Draft decision on Transpower's Central Park Wilton B Line listed project

Date of draft decision: 13 April 2017

Figure C1 | Central Park – Wilton B winter peak demand forecasts

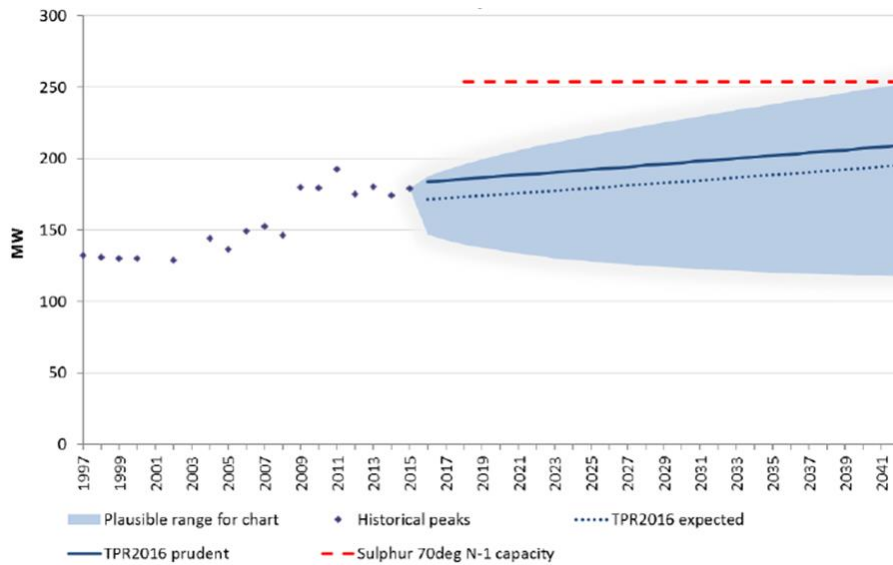
- C33 The demand forecast used by Transpower, shown in Figure C1 below, confirms that the capacity of the line is sufficient to meet expected demand to beyond 2040. This confirms that the proposal to maintain the existing capacity is appropriate compared to the alternatives of upgrading or downgrading its capacity.

- C34 We are satisfied that the assumptions for the peak demand forecast are reasonable. The forecast confirms that Transpower does not need to increase the capacity of the line to cater for future growth in peak demand. The forecast also confirms that there is an on-going need for this line.

- C35 Demand forecasts are difficult in the present environment because new technologies and consumer behaviour have the potential to decrease future peak demand.

- C36 Significant generation in the vicinity of the line may also require an increase in capacity. While no generation is planned or forecast in the Electricity Demand and Generation Scenarios (EDGS), additional generation could be installed within the lifetime of the new conductors. Feasible generation includes upgrading the existing windfarm or even interspersing solar farms within the existing windfarm infrastructure. We do not consider that these scenarios need to be allowed for now because the section of the line from the generation site to Wilton can be upgraded at a later date if required.
